3 Volt Intel StrataFlash[®] Memory

28F128J3A, 28F640J3A, 28F320J3A

Specification Update

Order Number: 298130-014

Figure 1. AC Waveform for Standard Word/Byte Read Operations

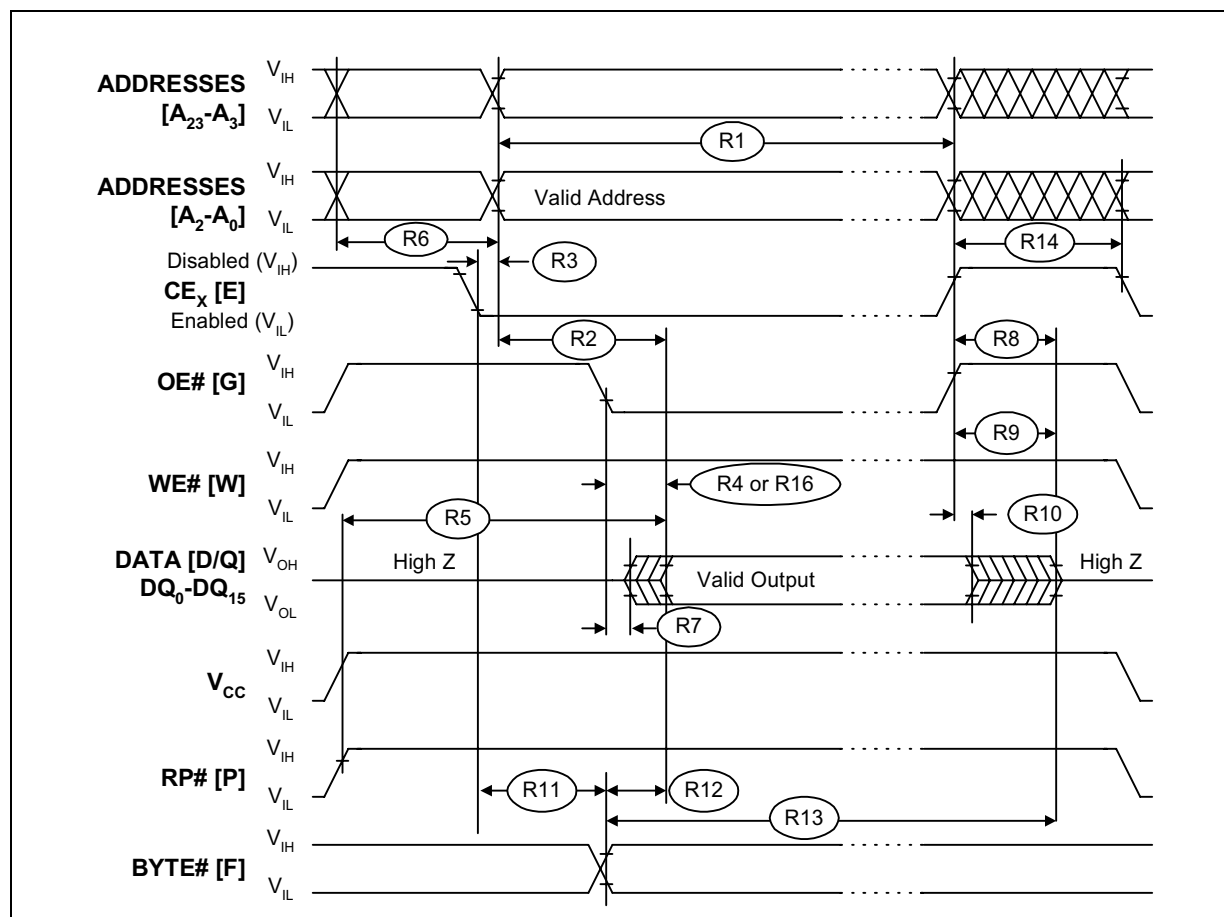
Problem: Devices need the parameter t_{ELQX} = 150 ns minimum. CE low to output in low Z (t_{ELQX}) is designated as R6 in Figure 1, in this Specification Update revision.

Problem: Devices need the parameter t_{ELAV} = 500 ns maximum. Chip Enable to Address Valid (t_{ELAV}) is designated as R3 in Figure 1, in this Specification Update revision.
